ET Docket 98-153

**In the matter of revision of Part 15 of the
Commissions's rules regarding ultrawideband
transmissions systems**

**Comment on Notice of Proposed Rulemaking
(FCC 00-163)**

**by
Robert Bosch GmbH
Division K8**

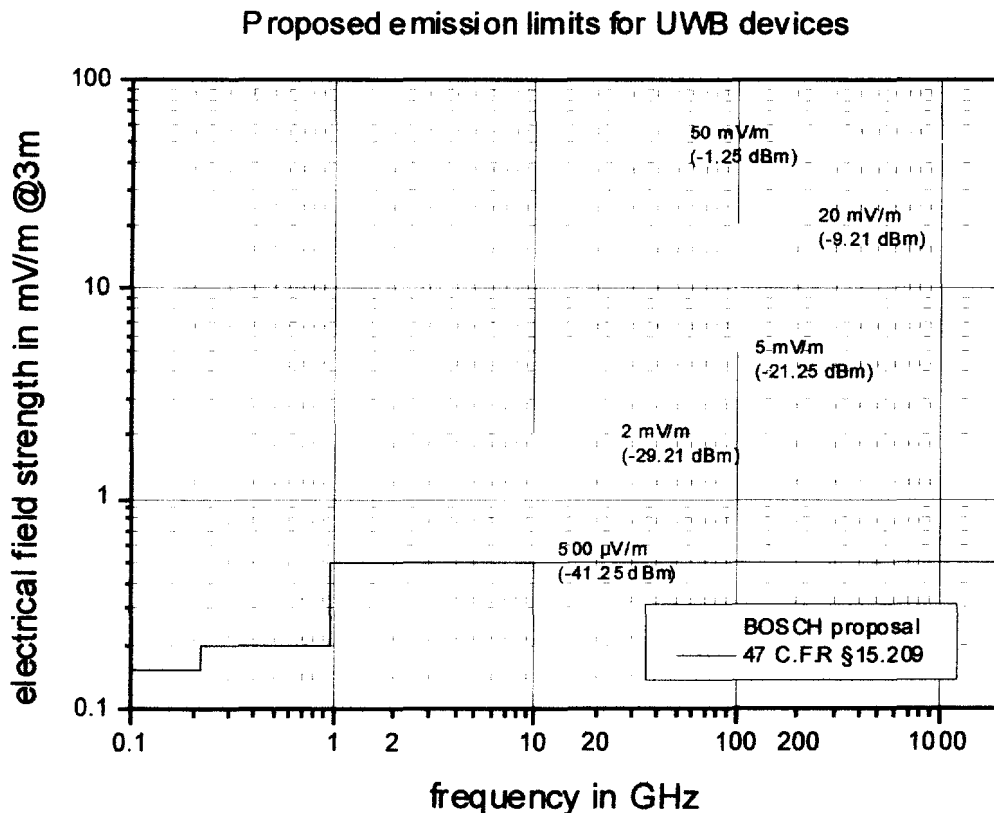
39. In principal we agree with the FCC, that the general emission limits contained in 47 C.F.R. §15.209 are an appropriate approach for UWBs working above 2 GHz. Though the FCC should consider higher limits with rising frequency, because the higher the frequency, the lower the power level and therefore the interference level received through an antenna of a victim receiver as mentioned under section 27. The interference level decreases with the square of the wavelength. We suggest the following extension of the §15.209 table for UWB emission limits:

We think, as a lot of UWB applications will be settled in the upper GHz region of the spectrum in the future due to lower semiconductor prices, further limits above 960 MHz should be established.
